Supplementary Report

To: CENTRAL COAST LOCAL PLANNING PANEL
From: Amy Magurren
Subject: Report – Incorrect report uploaded
Date: 16 December 2024
Ref: DA/2056/2023 – Multi Dwelling Development – 4 Units
Location: 140 Trafalgar Ave, Umina Beach

Item No: 3.3
Title: DA/2056/2023 - 140 Trafalgar Ave Umina Beach - Multi- Dwelling Housing - 4 Units - Modified
Department: Environment and Planning

Figure 6: Originally proposed development

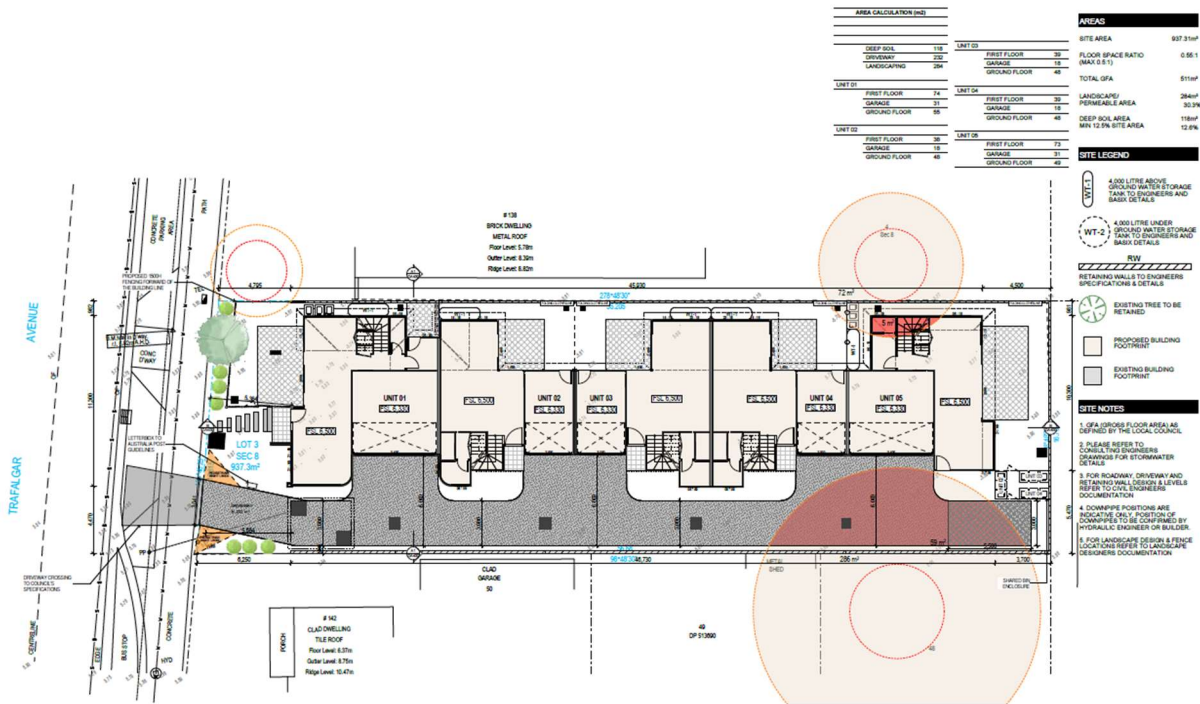
On the 5th of August 2024, a request for information was issued to the Applicant outlining the following issues with the development:

- **Height of Buildings** – Building height is to be indicated from existing ground level, not finished ground level and indicated on all elevations and sections, so correct setback calculations could be made.
 - **Floor Space Ratio** - The clause 4.6 request to vary the development standard lacked adequate justification for the exceedance in the floor space ratio control and was not supported.
-

- **Site Coverage** – Areas of permeable paving are not considered soft landscaping and should be removed from the calculation of site coverage. The permeable paving areas for the driveway and parking areas are not consistent with the areas indicated on the landscape plan. On this basis the site coverage calculations did not appear to be accurate, and the proposed development did not provide adequate soft coverage and deep soil areas.

- **Setbacks** – The development proposed variations to the front, rear and both side setback controls.
- **Facades and Articulation** – The proposed development did not include adequate articulation to the northern elevation including an unbroken wall of 33m in length.

- **Sunlight** – It is acknowledged that the irregular arrangement of the lots in this location mean that some overshadowing will occur to the properties to the south however the unbroken length of the building did not attempt to reduce the impact to the neighboring property to the south in terms of providing any building separation to allow sunlight to ensure adequate levels of sunlight are maintained to the neighboring dwellings.

- **Privacy** – Balconies overlooking the neighboring property were poorly positioned which resulted in significant screening that almost completely encloses the balcony.

- **Car Parking** – The proposed development required 8 parking spaces for residents and one visitor space. The application did not contain a visitor space and combined with the removal of an on street carparking space it is unclear why the provision of a carparking space was not included.

- **Landscaping** – The landscape plans were inconsistent with the architectural plans provided and conflicted with the proposed development plans.
- **Waste Services** – Waste generation rates used in the WMP were inconsistent with Council guidelines. Waste storage areas were inadequate to support the reasonable movement of bins from the storage area to the front of the site for collection.

- **Driveway** – Inadequate information in relation to access and maneuvering throughout the proposed development was provided for Councils Engineering team to make an assessment.

Figure 6: Amended proposed development

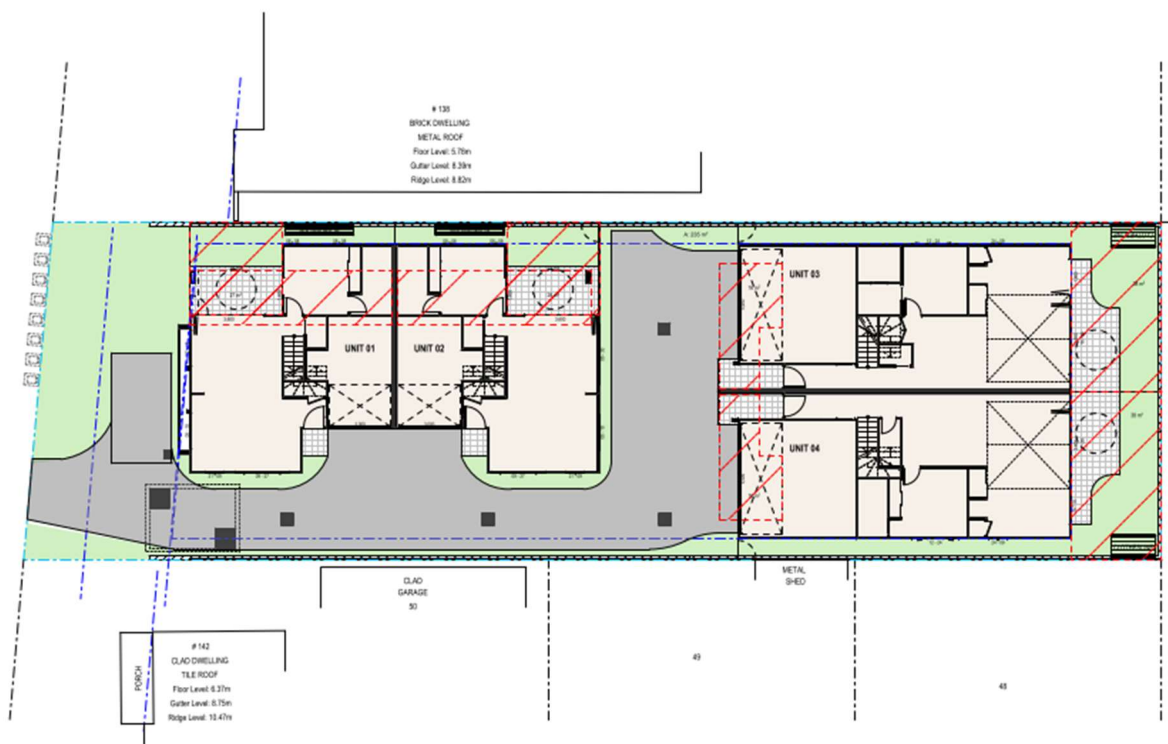
- **FSR** – Reduced FSR to 0.5:1 is more reflective of the expected density for the site.
- **Setbacks** – Front setback at 7.2m can be supported, given the rear setback is 4.5m which provides better amenity to the rear POS.

- **Side and Rear Setbacks** – Ground level at 1m, first floor at 1.9m & 2.04m can be supported. The increased setback on the boundary with #138 will improve/reduce the impact to the neighbours. The northern first floor POS will receive nice sunlight.

- Although there are no elevations provided to review, the separation of the built form improves the bulk and scale of the development and a much-improved solar impact to the neighbouring houses to the south.

- Privacy screens to the balconies have been provided.
- **Parking** – 6 spaces have been provided and 1 visitor space which can be supported.
- **Facades** have been suitably articulated, particularly at first floor level.

- Just noting the location of waste bins has not been included, should be considered in the final plans.
